Service Bulletin

Category 7	Applicable Model/s 1988-89 626/MX-6 & 929	Subject TURBINE SENSOR/PULSE GENERATOR	Bulletin No. 067/89 Issued 10/12/89 Revised
---------------	---	---	---

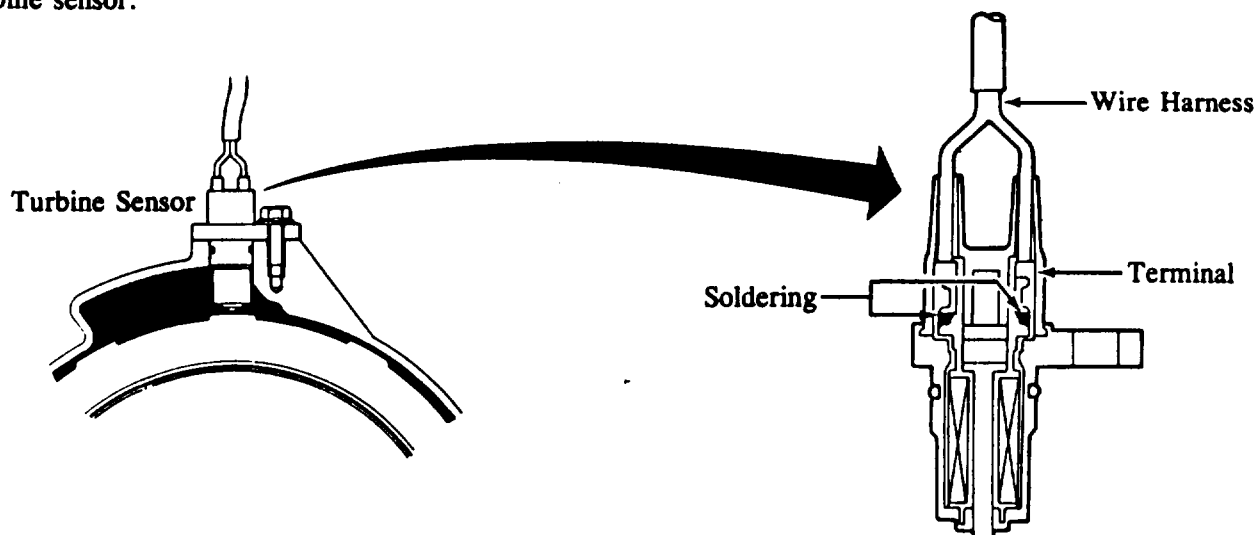
When judging the performance of the turbine sensor, wiggle the wire harness of the turbine sensor as illustrated below and check whether the resistance value is within the specification.

If a poor contact exists in the turbine sensor, resistance value changes and the value reads out of specification when wiggling the wire harness.

Model	Resistance Specification
626/MX-6	200-400 Ω
929	Approx. 245 Ω
